TECHNICAL MEMO # 308

Subject HD28 H.D Deep Interlock

Date: 27th October 2017

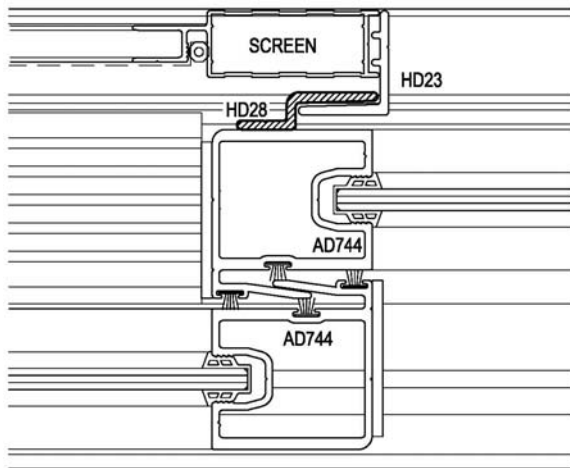
We are please to advise we have developed a new heavy duty screen interlock section, HD28. HS28 is for use with ProGlide specifically when used with the clip in screen adaptors AD787, AD788 and AD789.

Previously when using HD22 interlock, it required a packer back to the door interlocks. HD28 no longer requires a packer.

PROGLIDE

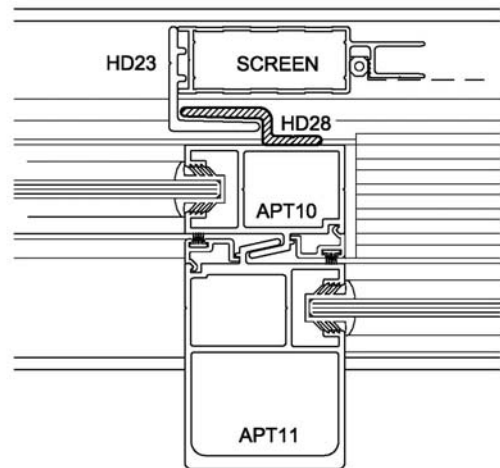
HD28 can also be used in Altitude.
